The Noble Hardee House

26-000712-COA

Exterior Stabilization and Repair - Amendment*Written Project Description*

HR303

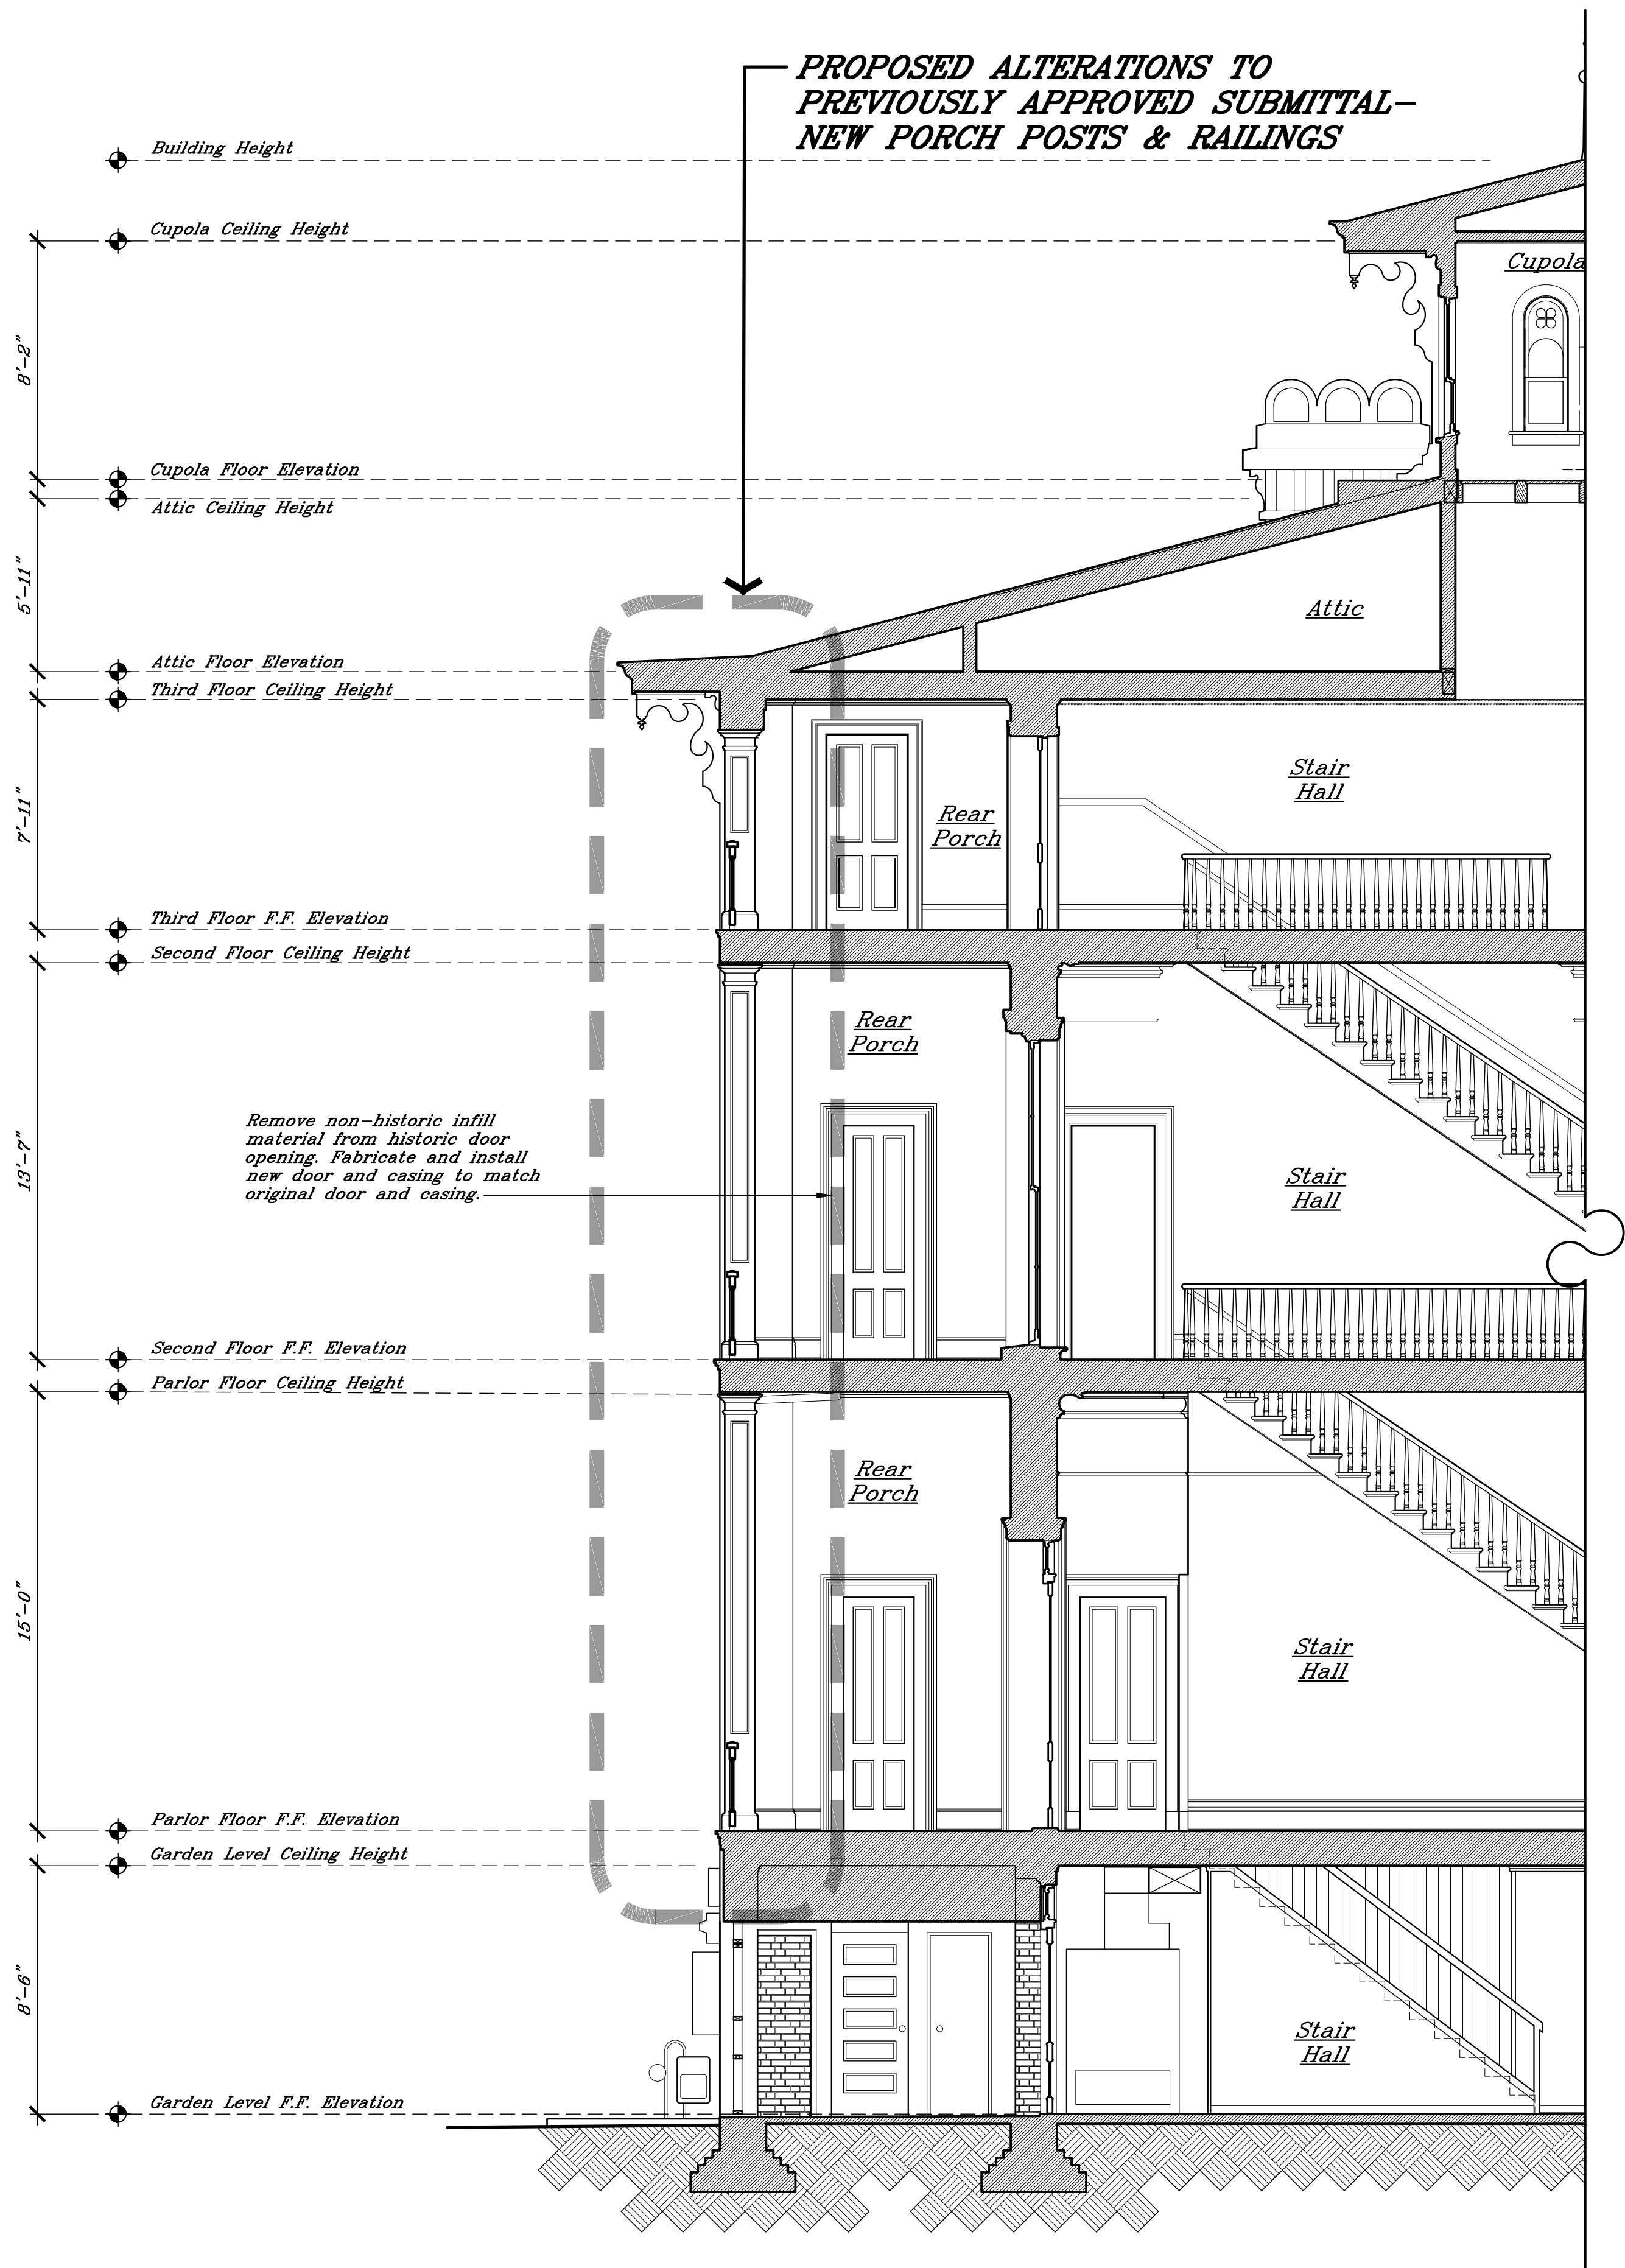
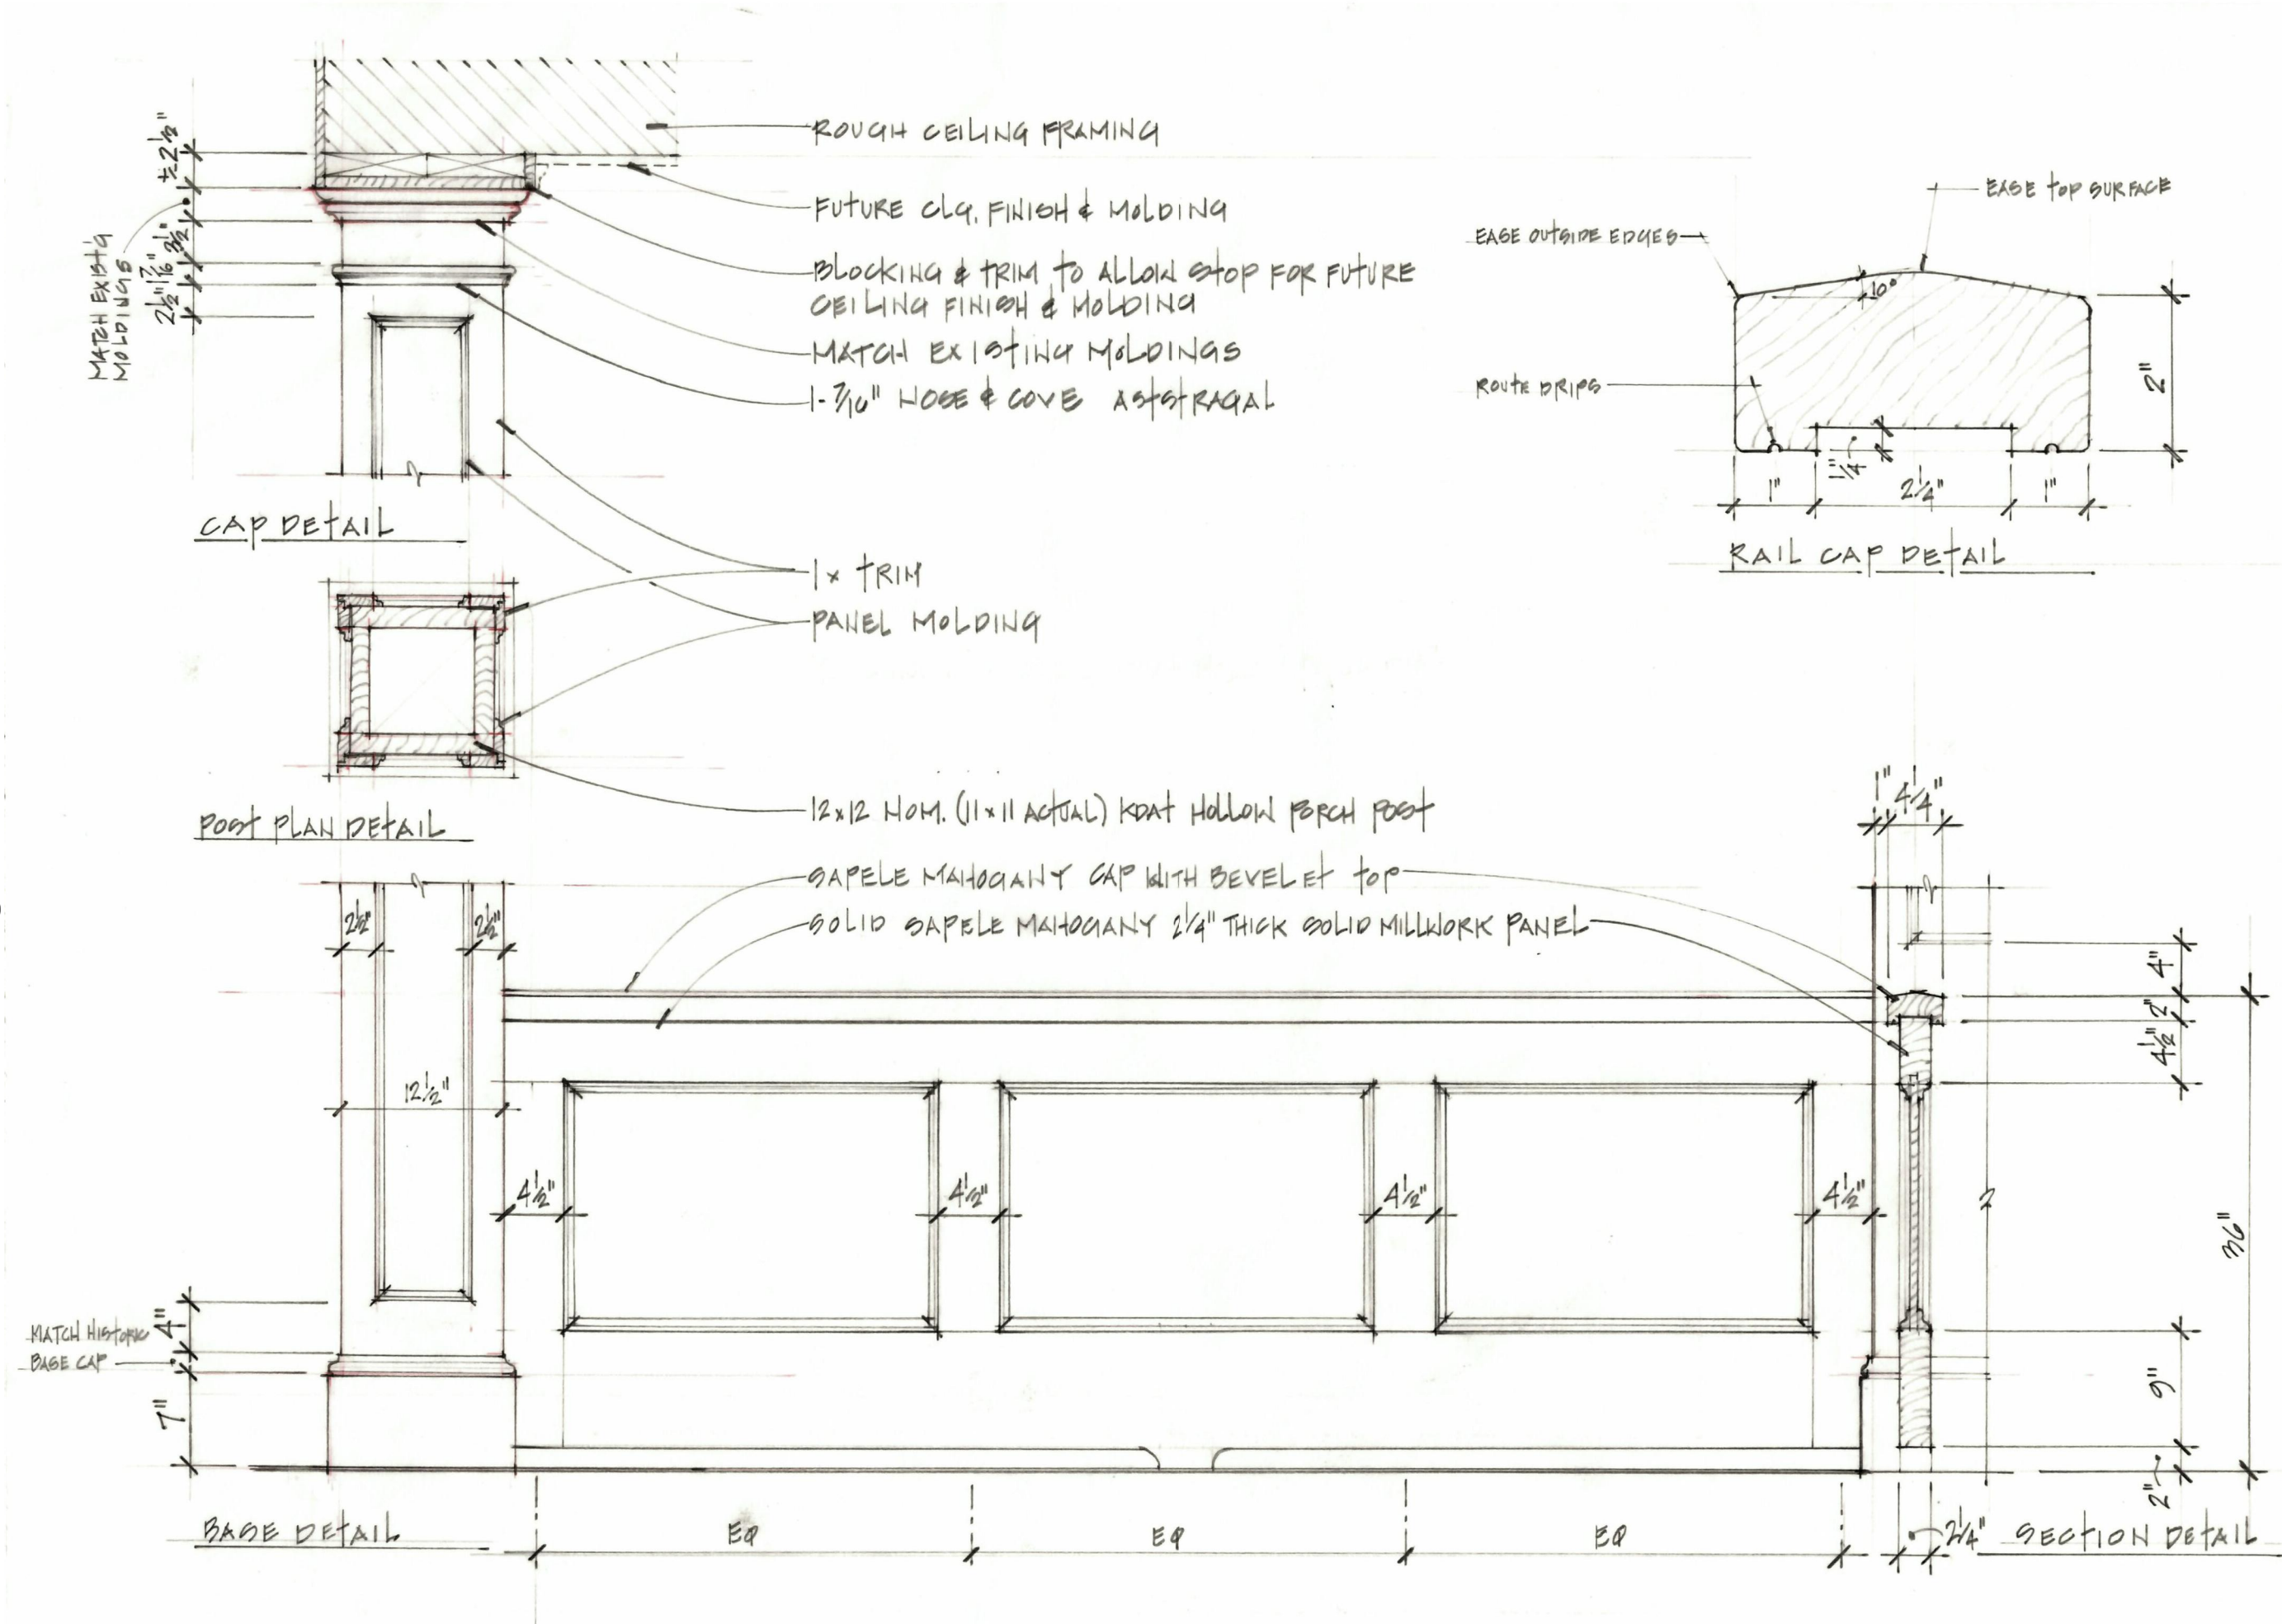
The proposed porch alterations retain the basic configuration that exists today, due to the lack of evidence to indicate the original appearance; however, the panelized porch piers will be increased in their cross section from (11-1/2" x 4") to (11-1/2" x 11-1/2"). The width facing the public lane will be retained, while the side depth will be increased to create a square pier cross-section. Square porch piers are more in keeping with the period of the house and will solve the currently compromised structural condition resulting from the slender posts. The panelized railings will likewise be re-constructed out of solid wood millwork, but slightly thicker than the existing panels to resist lateral forces and deflection over time. They will be 2 inches taller to meet minimum modern safety standards. All new work will be constructed of high grade natural wood millwork. No artificial or synthetic materials are proposed.

6. **Portico and Porches:** Repair and restore historic porches and portico. Material damaged beyond repair is to be replaced in-kind, matching existing original materials, profiles and configurations. Stabilize and repair lightly damaged material in situ to the greatest extent possible. Material that requires structural or structural repairs shall be replaced in-kind to match original. Prime and paint to match existing.
